UNITED STATES PATENT AND TRADEMARK OFFICE

APPLICATION NO.	FILING DATE	FIRST NAMED INVENTOR	ATTORNEY DOCKET NO.	CONFIRMATION NO.
10/605,660	10/16/2003	Sung-Fei Wang	10041-US-PA	2659
31561	7590	02/18/2005	EXAMINER	
JIANQ CHYUN INTELLECTUAL PROPERTY OFFICE 7 FLOOR-1, NO. 100 ROOSEVELT ROAD, SECTION 2 TAIPEI, 100 TAIWAN			NGUYEN, THINH T	
			ART UNIT	PAPER NUMBER
			2818

Office Action Summary	Application No.		Applicant(s)	
	10/605,660		WANG, SUNG-FEI	
	Examiner		Art Unit	
	Thinh T. Nguyen		2818

DETAILED OFFICE ACTION

FIG. 2

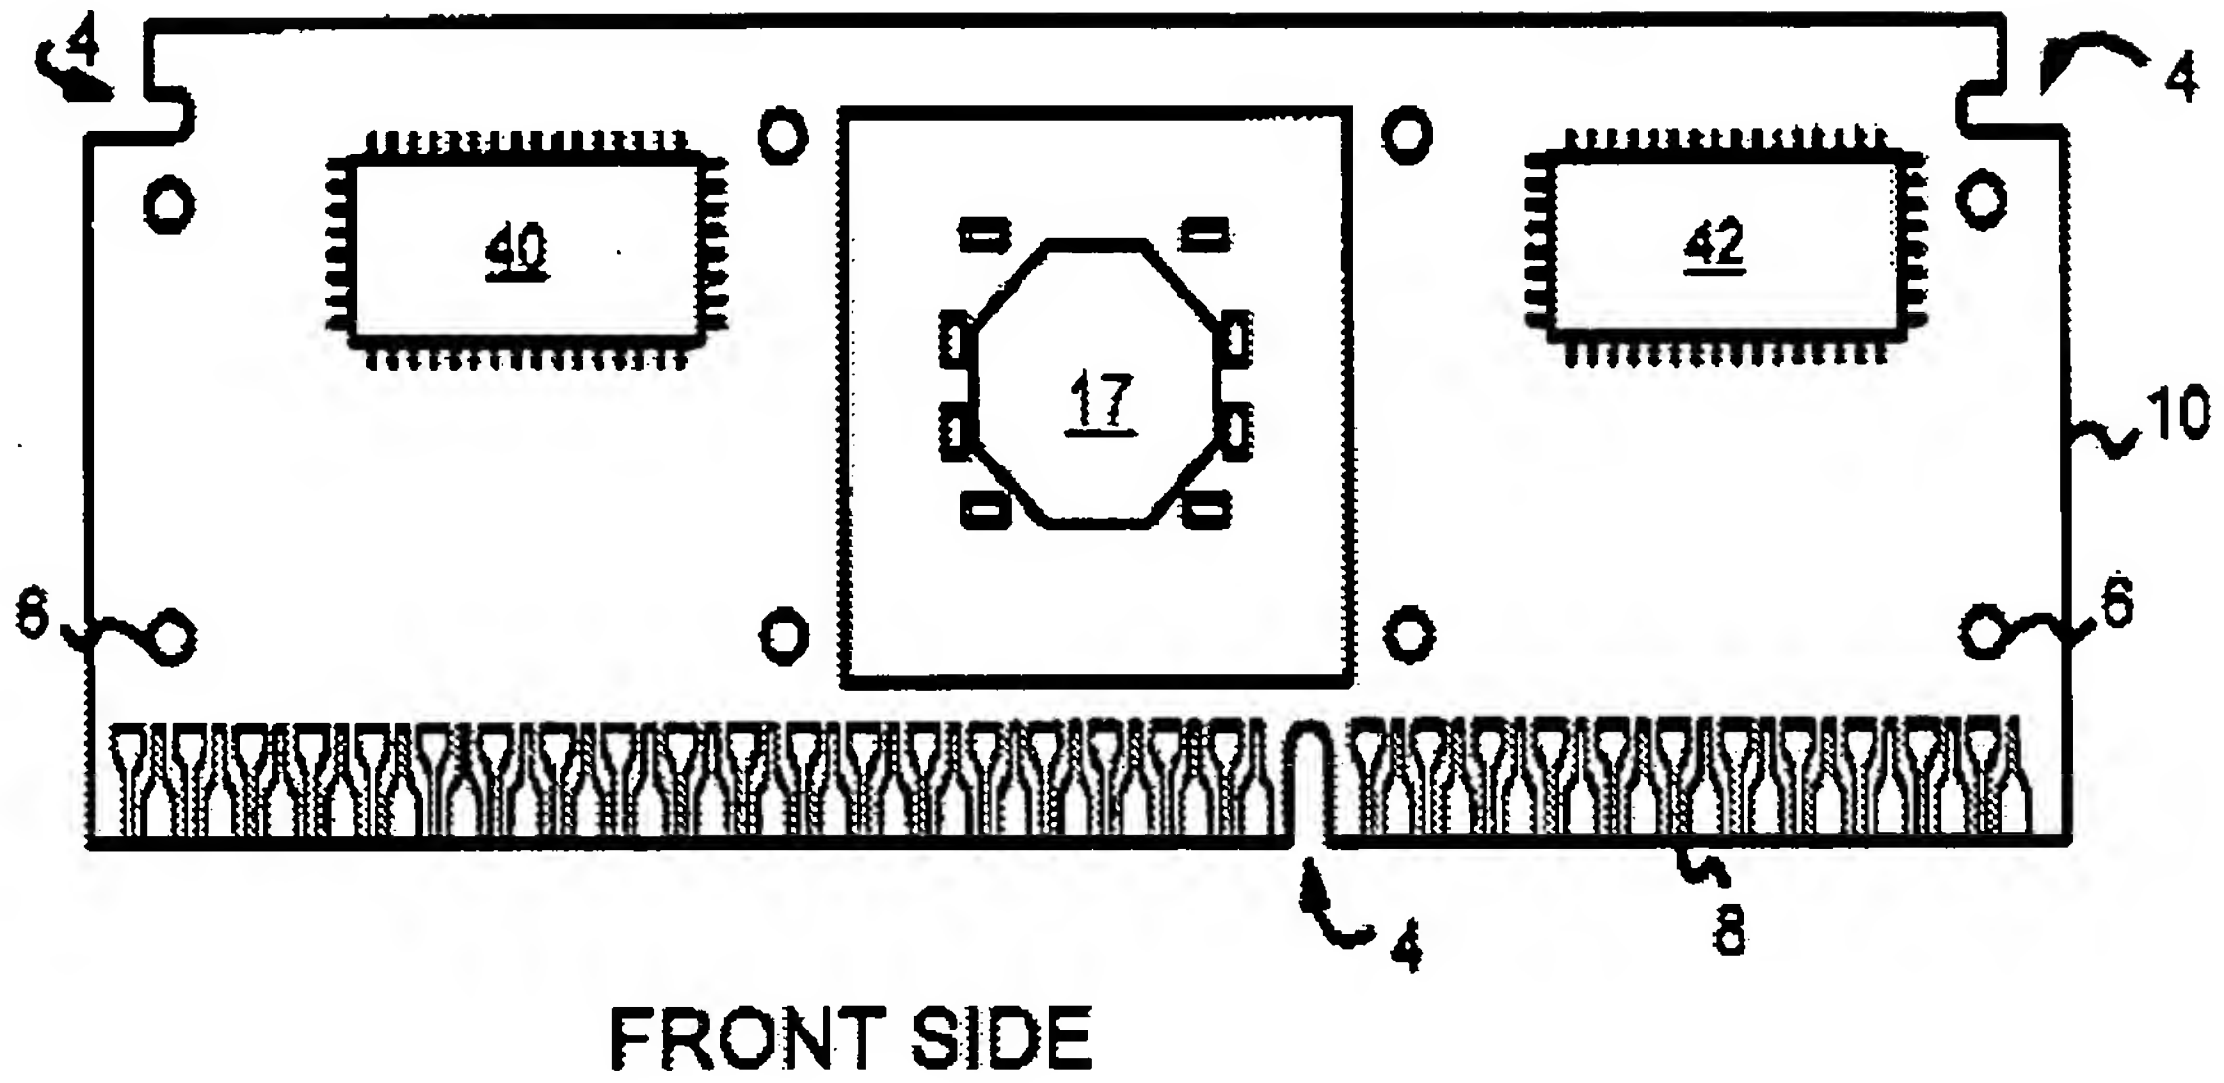
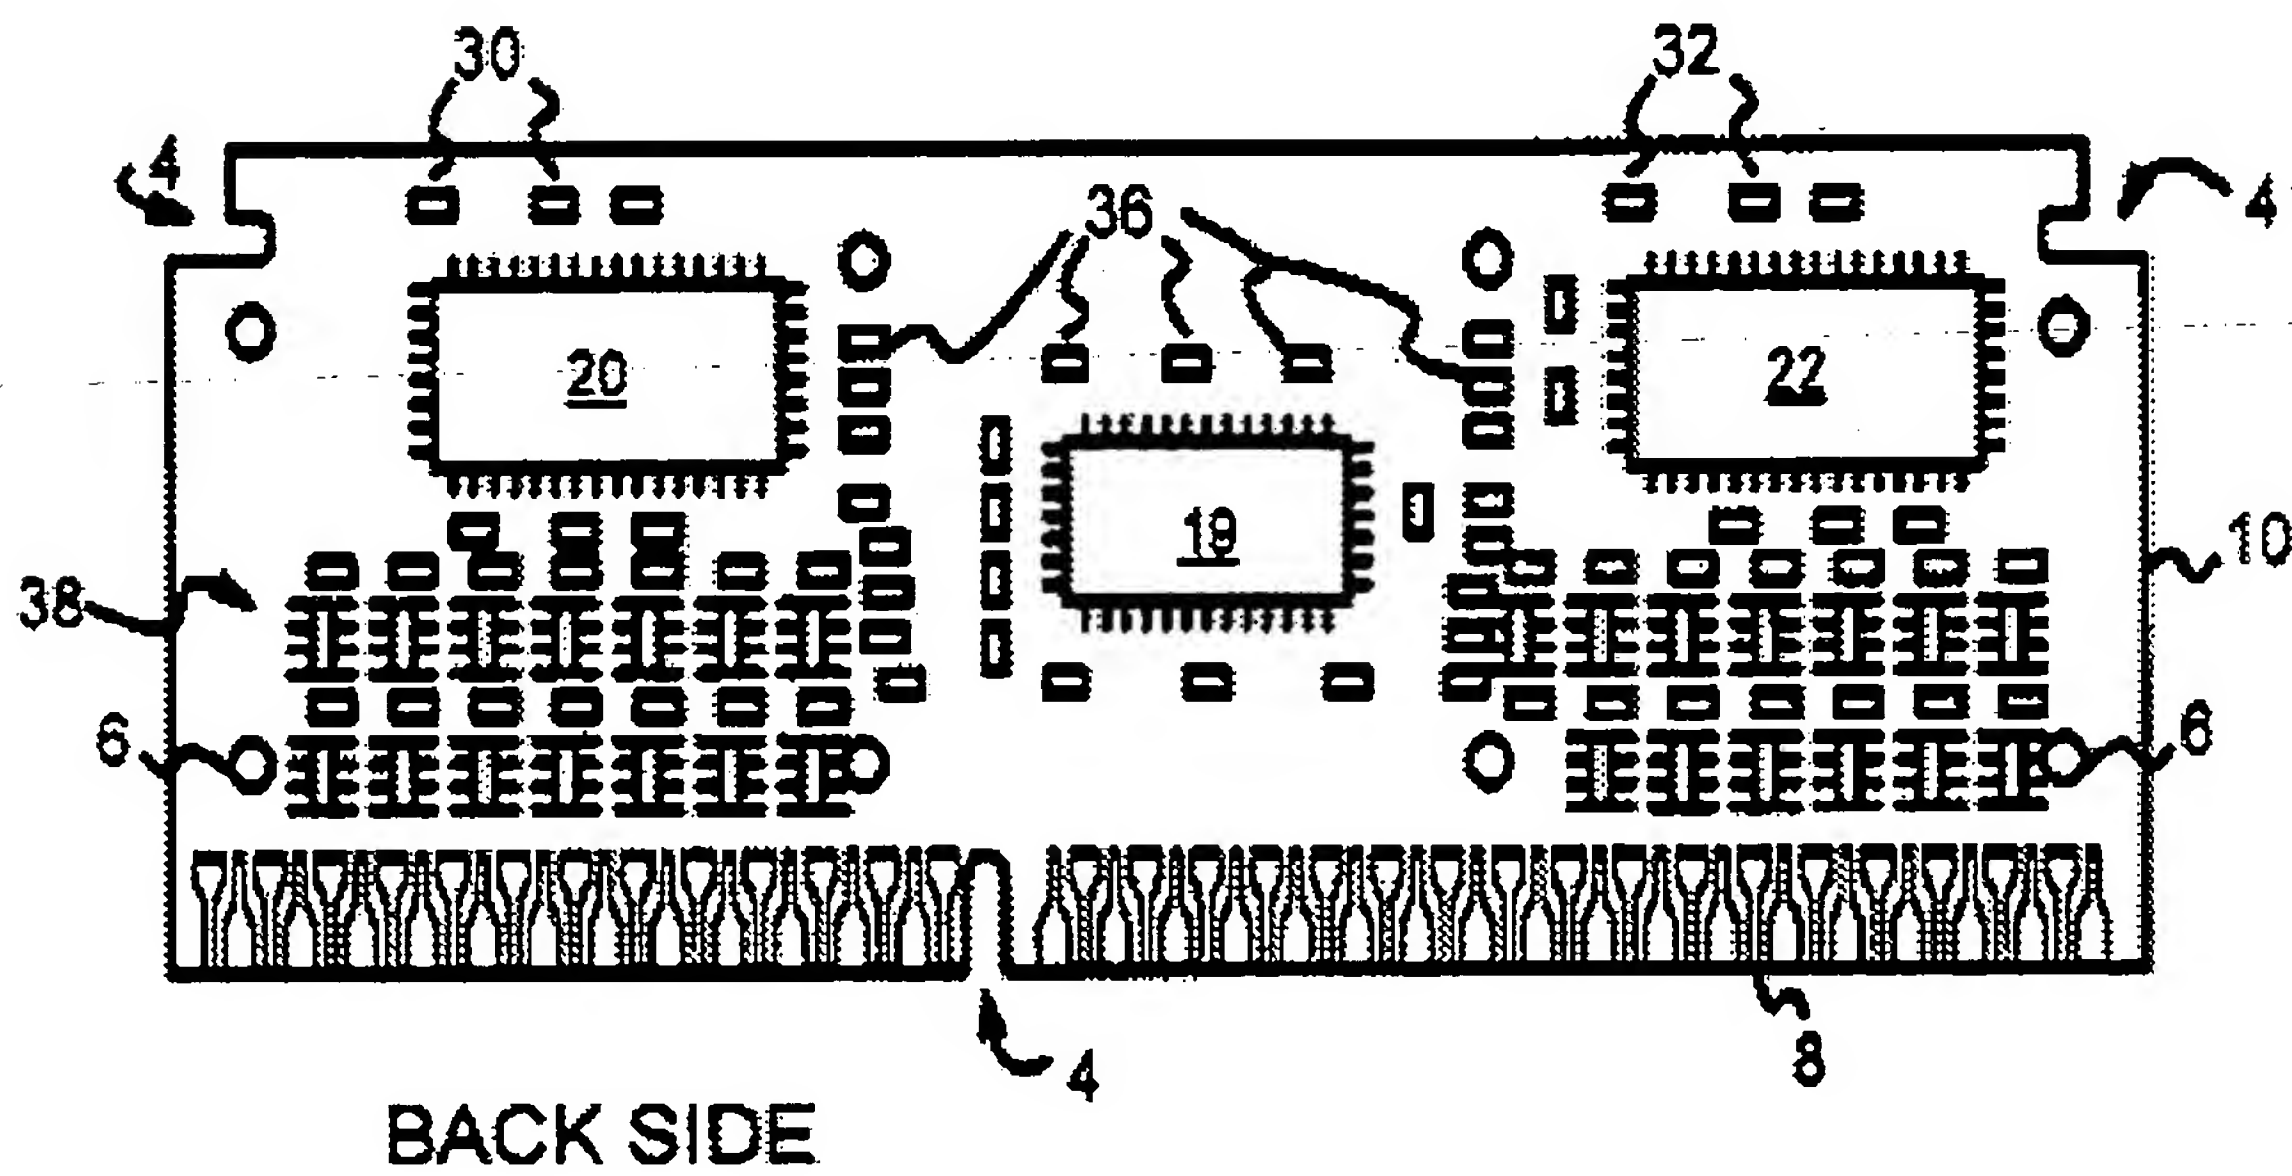
Chu (fig 2,the abstract) discloses a high density semiconductor package, comprising: a substrate, having a surface; a first package module (fig 2 reference 17,19), being disposed on the surface of the substrate; and a plurality of second package modules, being disposed on the surface of the substrate surrounding the first package module, wherein a corner of each of the second package modules face a side of the first package module and wherein the first package is coplanar with the second packages module.

FIG. 1

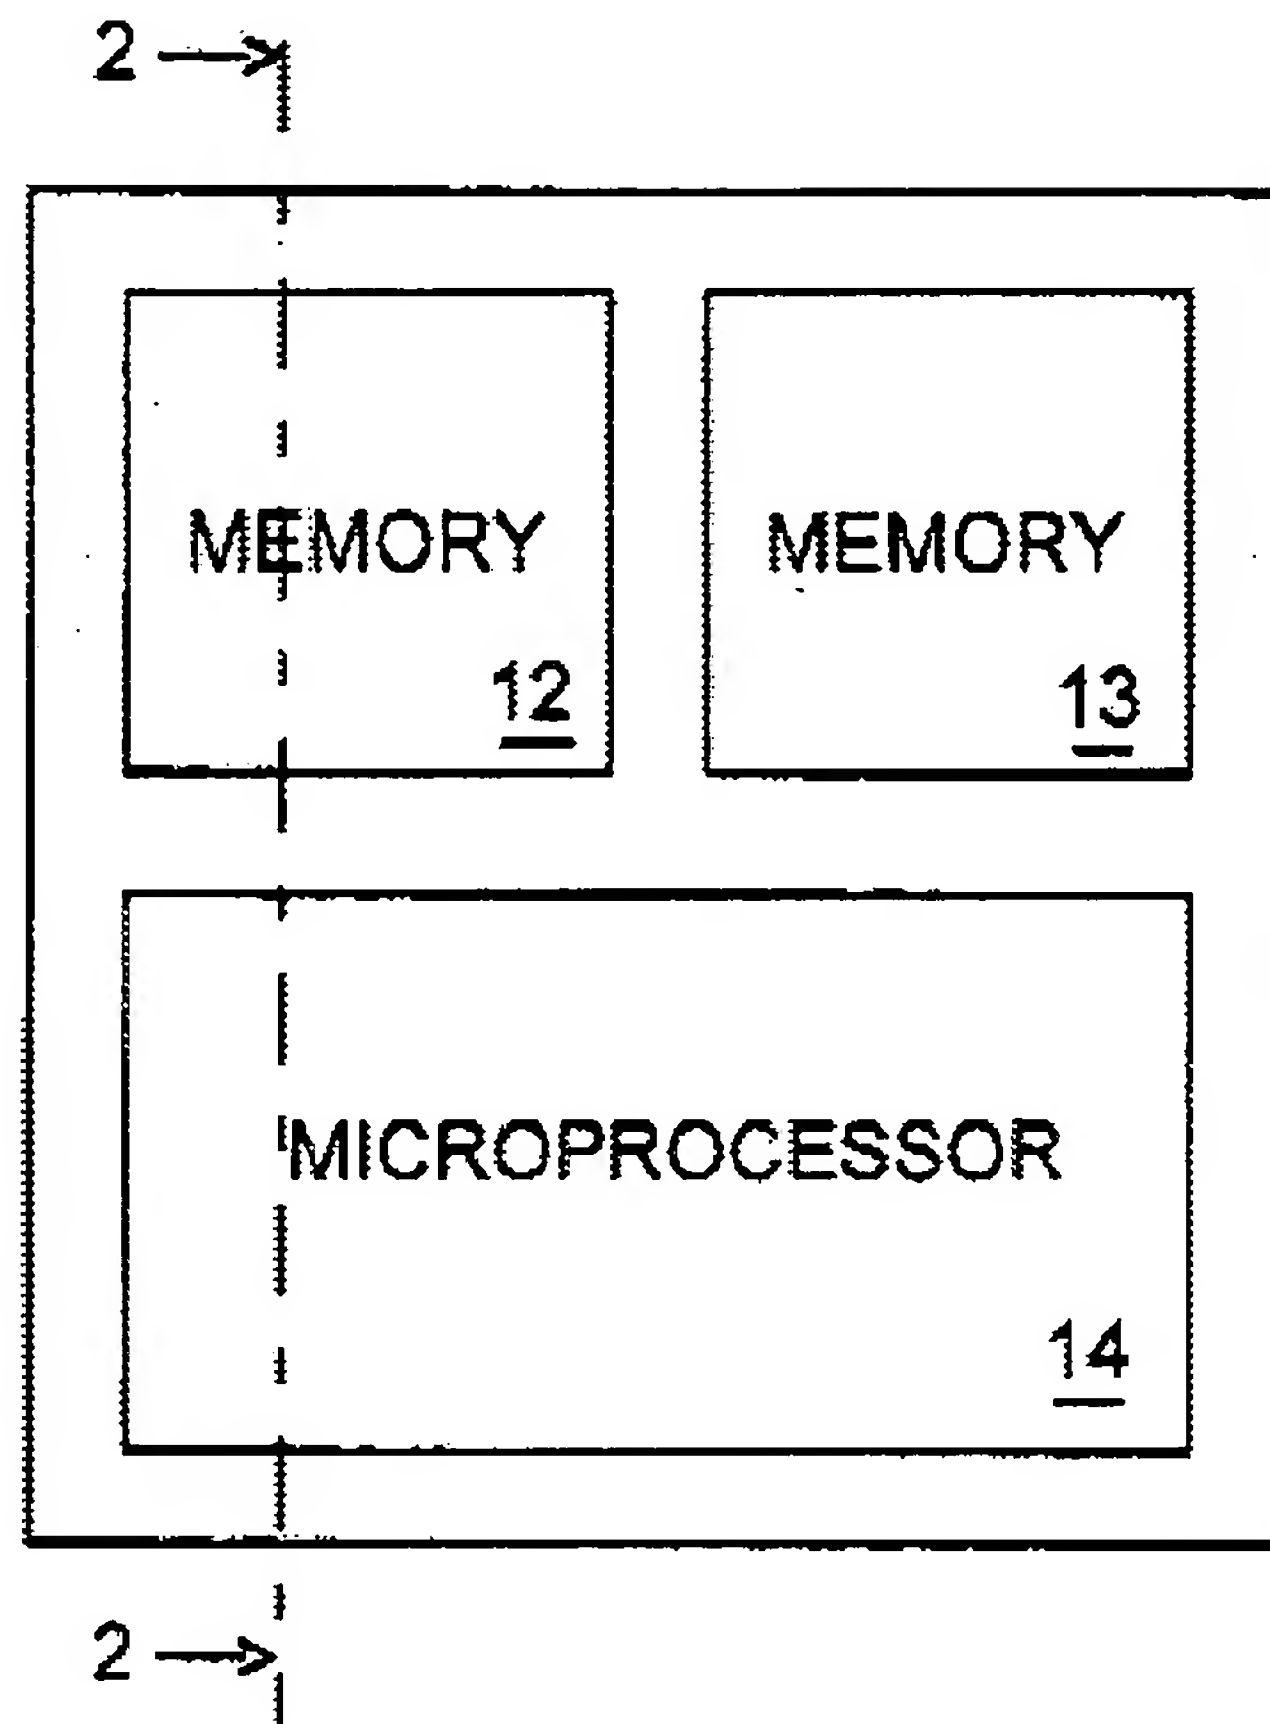
Similarly, Degani et al.(the abstract, fig 1) disclose the same invention.

Degani discloses (in the abstract, in fig 1) a semiconductor package wherein the first package module is arranged substantially non-orthogonal to the second package module.

FIG. 2

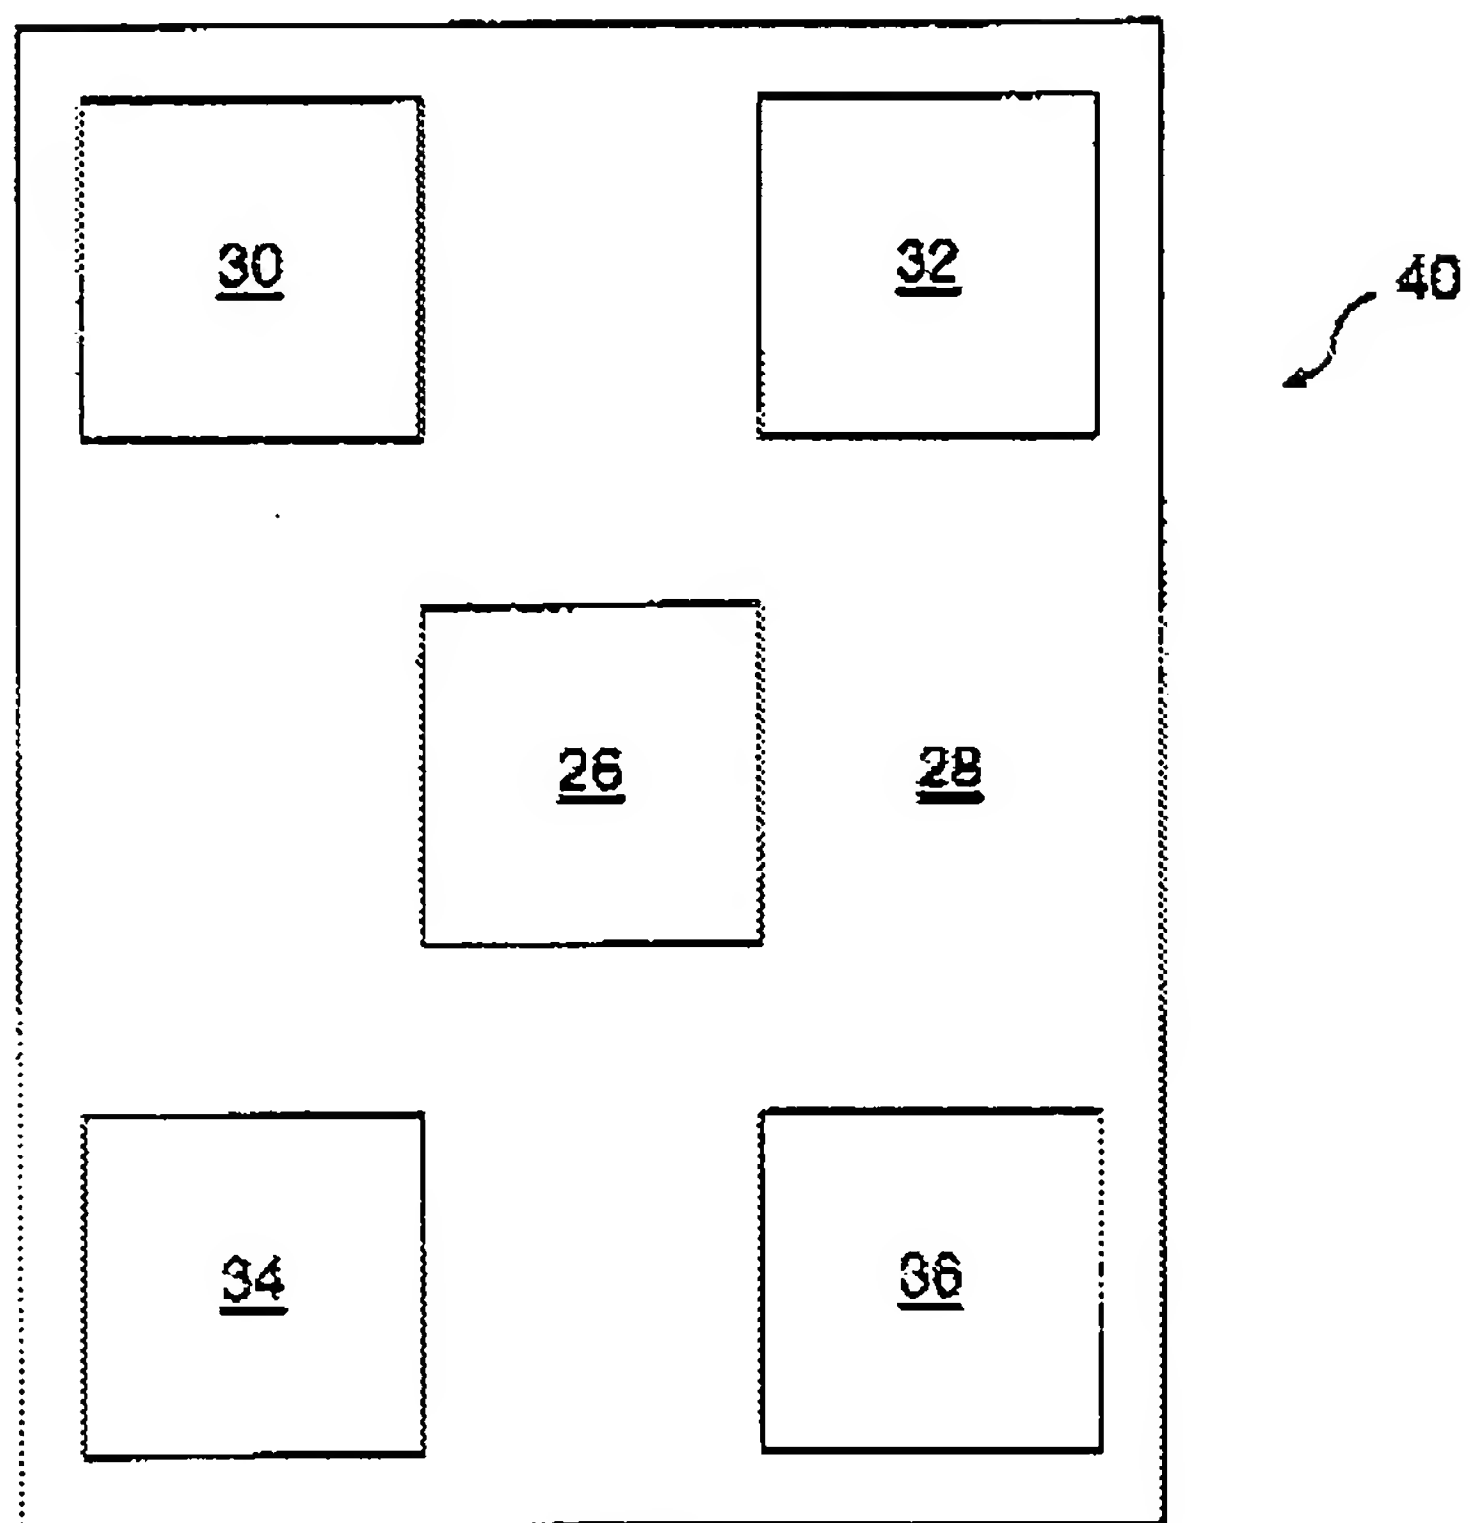
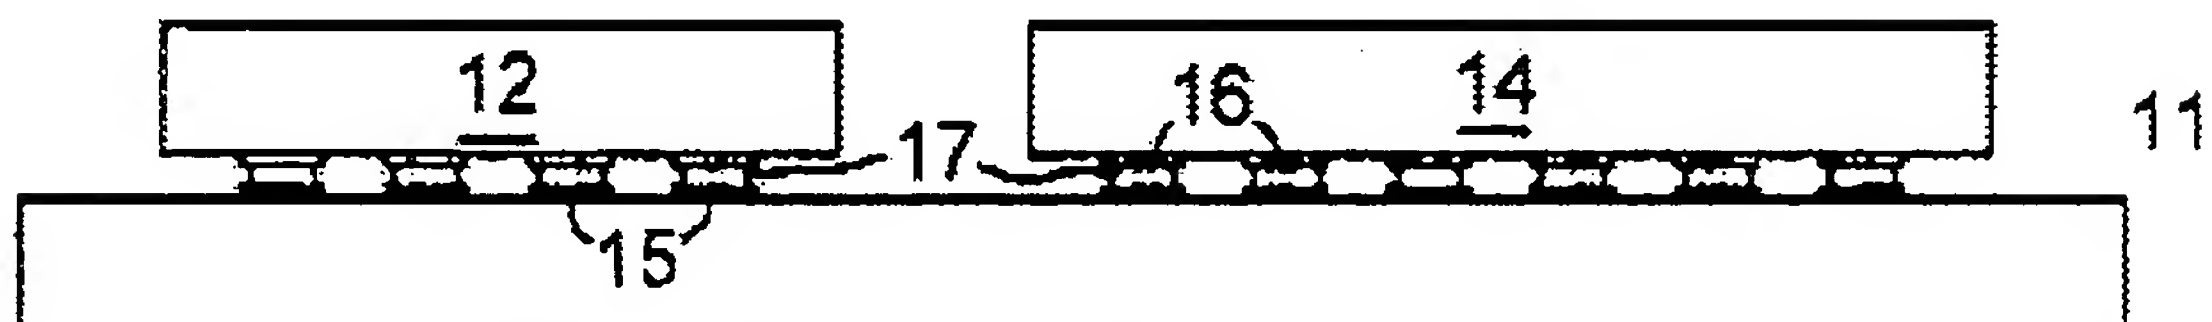
And furthermore, Brillhart (the abstract, fig 2) disclose the same invention

Brillhart (in fig 2, in the abstract) discloses a high density semiconductor package as wherein the first package module is arranged substantially orthogonal to the second package modules.
